Engineering Change Notification – GMB Circuit Breakers

Product group	PG790 Other Switching Products
Author	Craig T Coulter, Application Engineer
Date of notice	18 – October – 2022
Effective date	9 – September – 2022
Topic	GMB Series Marking Change
Distribution	Sales

GMB series Location of Marking Changed

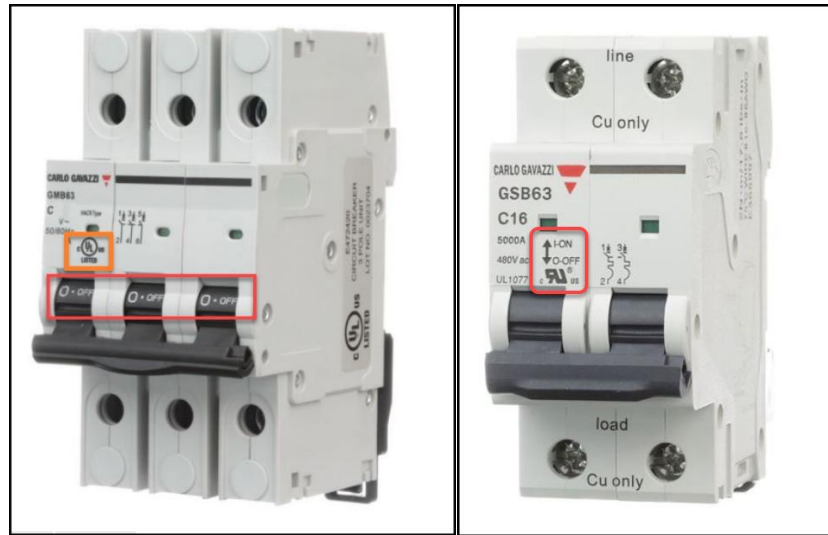
The location of the “I/O” (On/Off) is being moved from the Handles to the face of the breaker above the handles per attached pictures (red squares). In addition, the UL markings (orange square) are being moved to the side on the label.
